Arlington Zoning Board of Appeals

Docket # 3719: 1021-1025 Massachusetts Avenue

Re: Tetra Tech Comment Letter 2
Comprehensive Permit (40B) Peer Review
1021-1025 Mass Ave
Arlington, Massachusetts

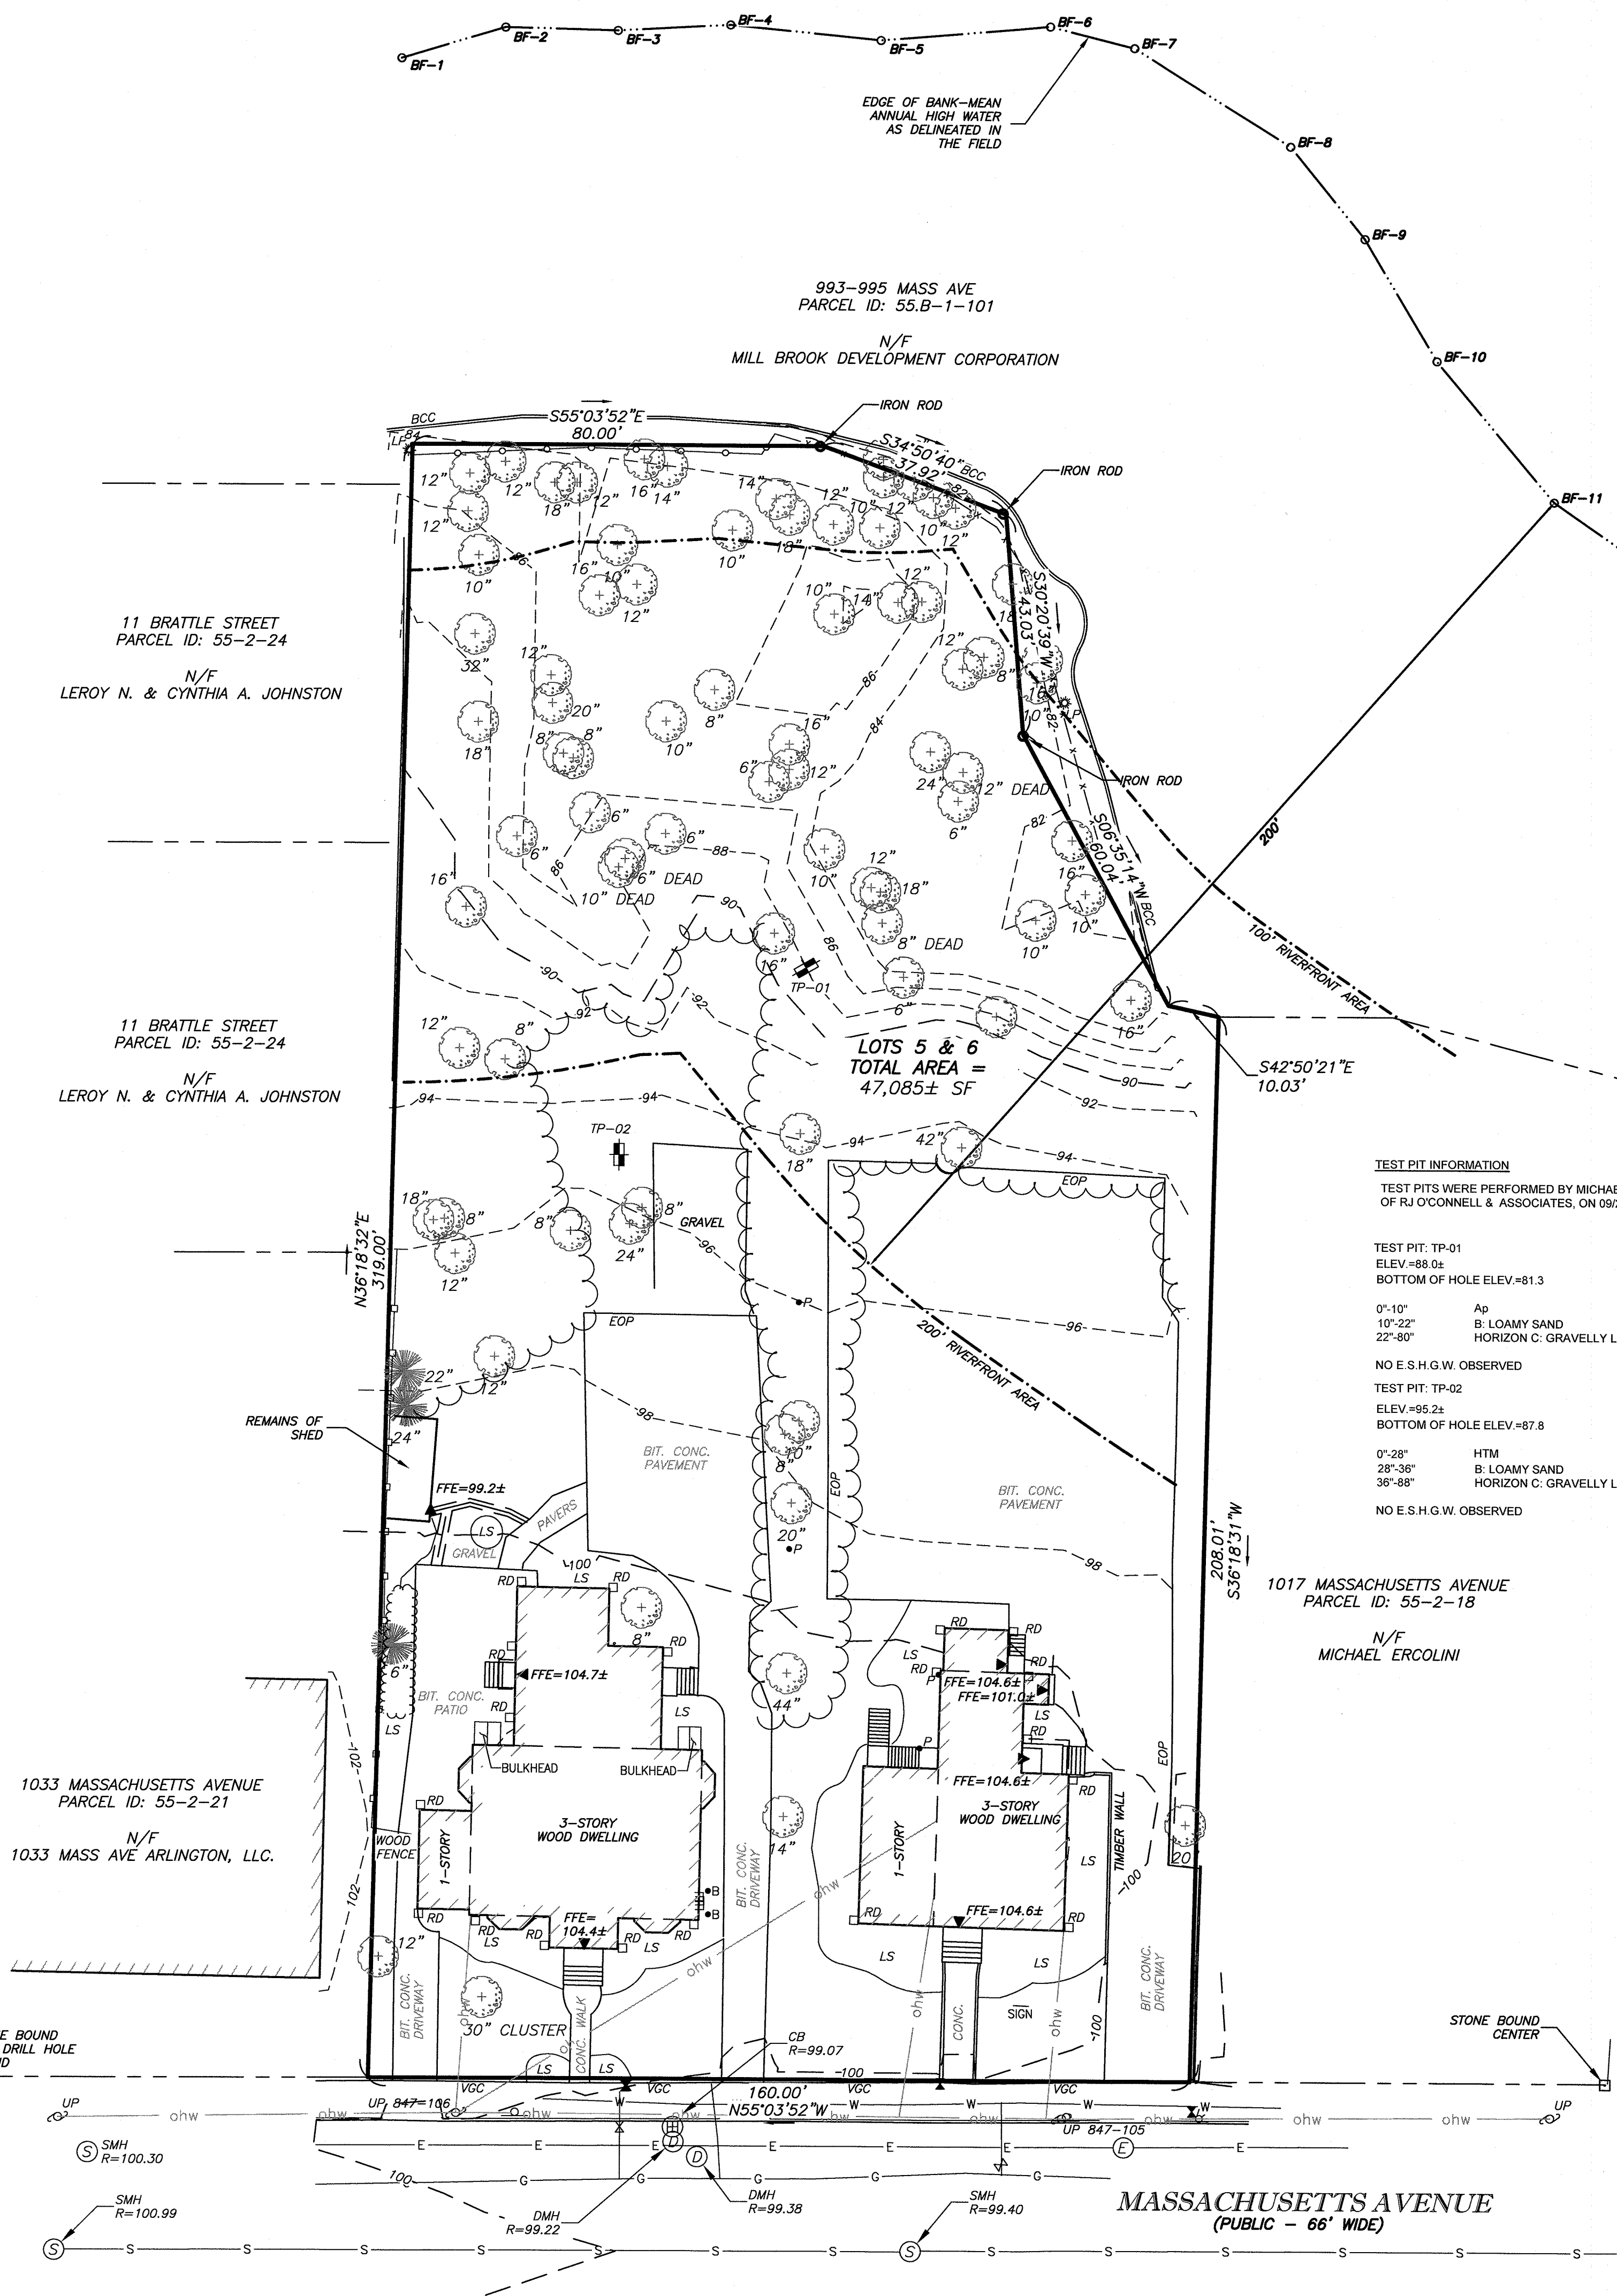
2. The site includes some special topographic conditions and very close abutters. We recommend the applicant provide contours at 1-foot intervals and that contours extend at least 4 feet past the property line to help understand how grading along the property line will be influenced by the Project.

3. Please confirm test pit information was provided by a licensed soil evaluator and provide license number if available. Please note, test pit information conflicts with that shown on the Site Demolition Plan

4. It would be helpful to include a datum reference comparing the Town of Arlington datum to the vertical datum used on the plan (NAVD88).

6. Show structures on abutting properties on all plans.

2023-02-17 Update – Comment addressed as requested. **Comment Resolved**

2023-02-17 Update – Comment addressed as requested. **Comment Resolved**

2023-02-17 Update – Comment addressed as requested. **Comment Resolved**

2023-02-17 Update – Comment addressed as requested. **Comment Resolved**

SITE DEMOLITION PLAN
LOCATED IN
ARLINGTON, MA
(MIDDLESEX COUNTY)
PREPARED FOR
1025 MASS AVE., LLC

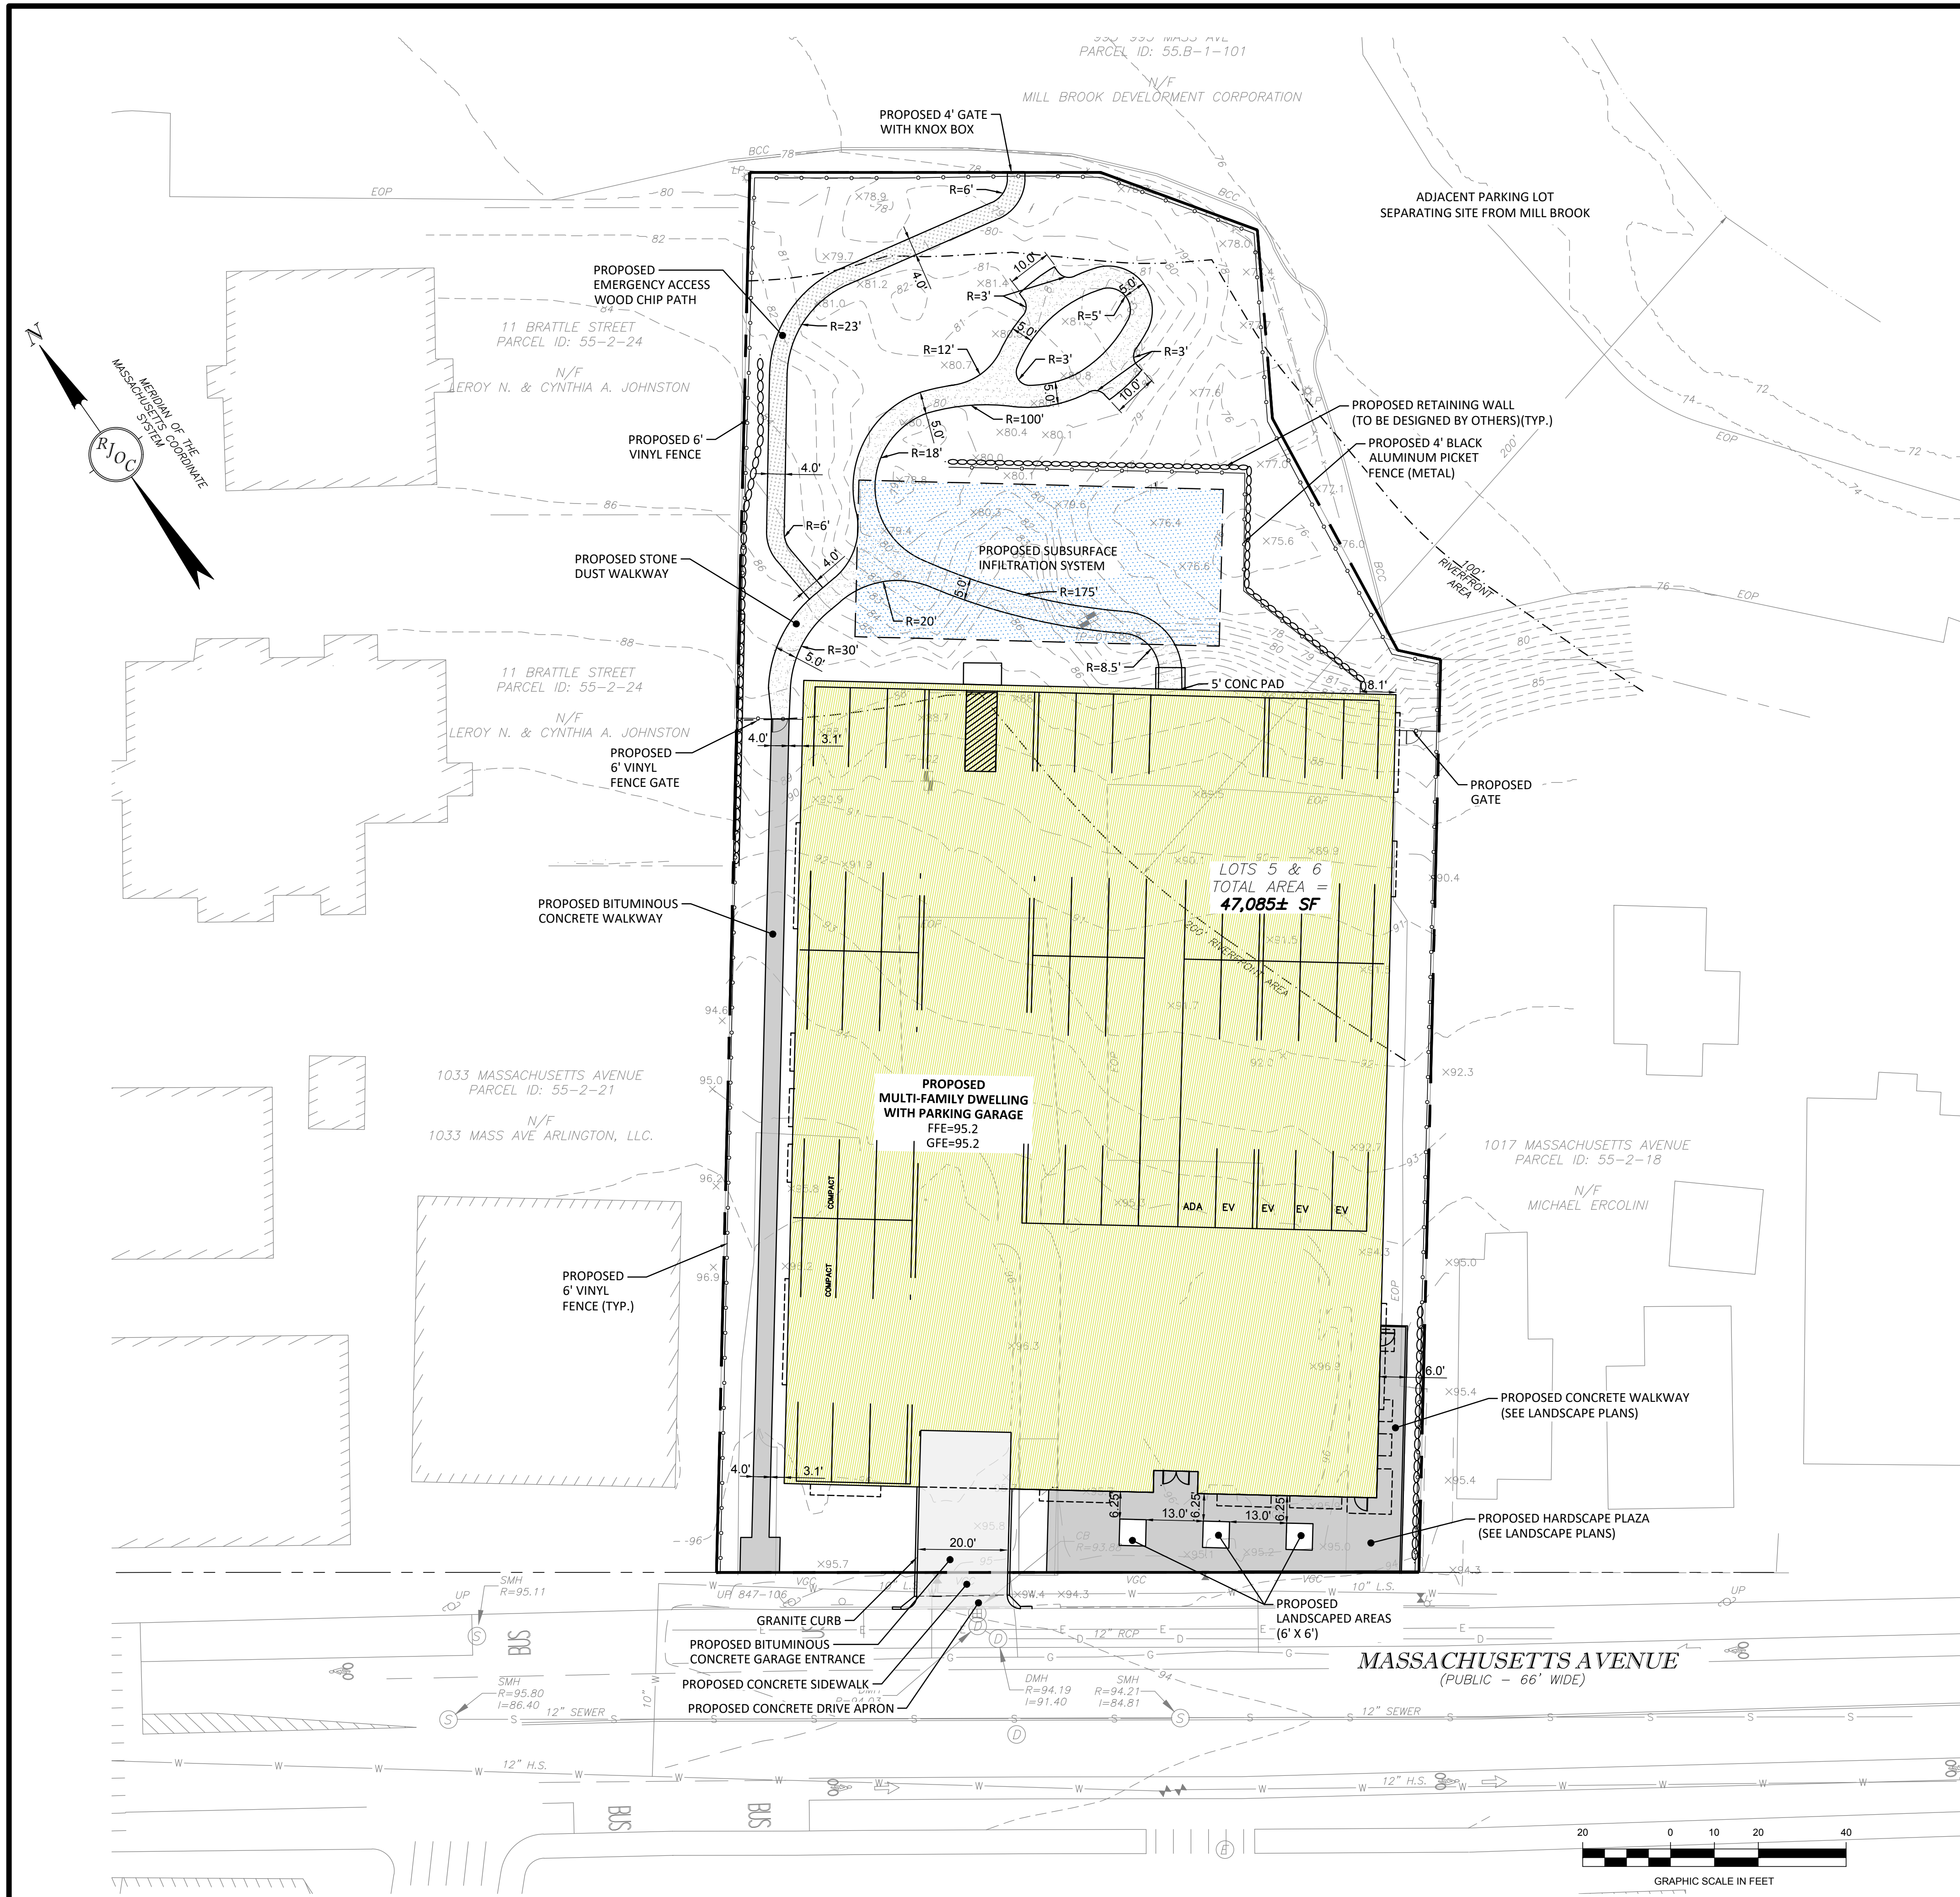
8. It appears the Project intends to save trees at the rear of the property. Although certainly commendable it appears several may be negatively impacted by proposed grading or will otherwise limit area likely needed to support construction. We recommend the applicant consider the area needed to support construction and revise the tree removal limits accordingly.

9. Does the Project anticipate installation of a temporary construction fence? If so, please show its location and gates on the demolition plan along with any proposed gates.

10. The plan shows a proposed construction entrance pad at the southeast corner of the site. However, the pad appears to extend into the proposed building footprint. Please clarify if this entrance is only to be used during demolition and if so where the entrance will be located during the balance of construction.

11. Provide contour labels.

12. Correct test pit information as needed to address inconsistency with information on the Existing Conditions Plan.

13. Is the existing fence between the subject property and 1033 Mass Ave proposed to remain or will it be removed? In either case, please note its treatment on the demolition plan

14. Please show anticipated sawcut/excavation limits for work within the public right of way. A sawcut line is include landscape plans but does not consider proposed utility connections.

2023-02-17 Update – Comment addressed as requested. **Comment Resolved**

2023-02-17 Update – Comment addressed as requested. **Comment Resolved**

2023-02-17 Update – No response provided however comment is addressed in plan revisions. **Comment Resolved**

2023-02-17 Update – Comment addressed as requested. **Comment Resolved**

2023-02-17 Update – Comment addressed as requested. **Comment Resolved**

2023-02-17 Update – Comment addressed as requested. **Comment Resolved**

2023-02-17 Update – Comment addressed as requested. **Comment Resolved**
